From: Vicki Harding [REDACTED]
Sent: 15 December 2021 12:33
To: Nathaniel Young [REDACTED]
Subject: 2021/4259/P Elm Tree House, 13 Netherhall Gardens London NW3 5RN

The Heath & Hampstead Society

Planning Ref: 2021/4259/P
Address: Elm Tree House, 13 Netherhall Gardens London NW3 5RN
Case Officer: Nathaniel Young
Date: 15th December 2021

Fig 12 Camden Arup study¹ 1:10560 geological map with rivers 1920-1

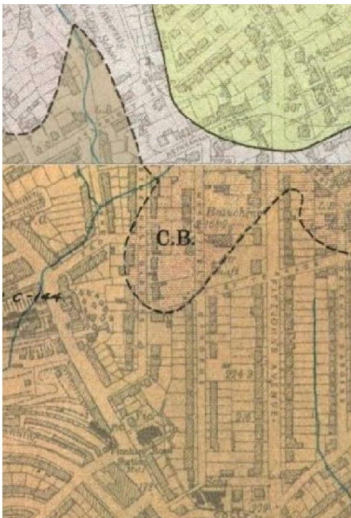
Despite the lack of appropriate testing, groundwater WAS found, though due to the method used there is no evidence of where it came from. The 1920 British Geological Survey (BGS) map (figure 12 of Arup, 2010¹) shows 13 Netherhall Gardens to be possibly on a spring line. It is certainly sited on the complex transition zone between the Claygate Beds and Band D of the London Clay Formation, with a still not inconsiderable amount of silt and water-bearing sand partings within the clay, found here but ignored. It should also be suspected that an intermittent aquifer exists beneath the superficial Quaternary Head deposit. This has been merely named 'Made Ground' and has not been recognised despite the fact that it was found to be up to 2.6 metres thick. Hampstead is the source of four of London's rivers for very good geological reasons.

from British Geological Survey Areas for Greatest Potential for Slope Instability

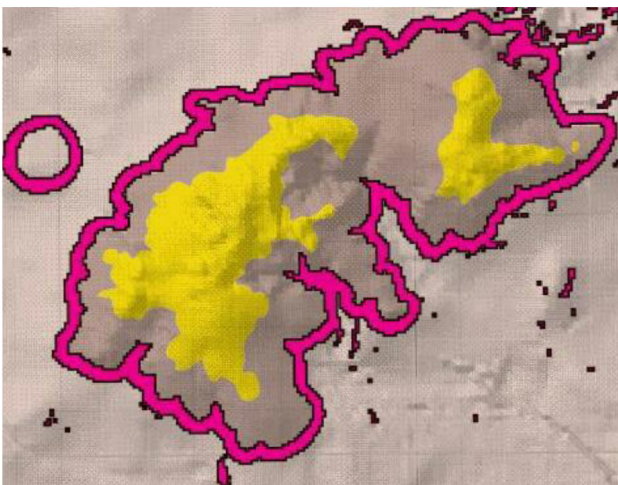
The BGS map of greatest landslide potential (figure 17 in the Arup (2010)¹ study shows that Imperial Towers is on the 'crimson line' of greatest potential for landslide and 13 Netherhall Gardens is on its edge. This is due to the high angle of slope here, the thick layer of overlying complex and laminated superficial quaternary deposits with Head propensity, and the presence of the intermittent aquifer beneath this deposit, as well as the many sand partings that run through this transition zone that can carry groundwater and were present in both Boreholes 1 and 2 during a period of low rainfall.
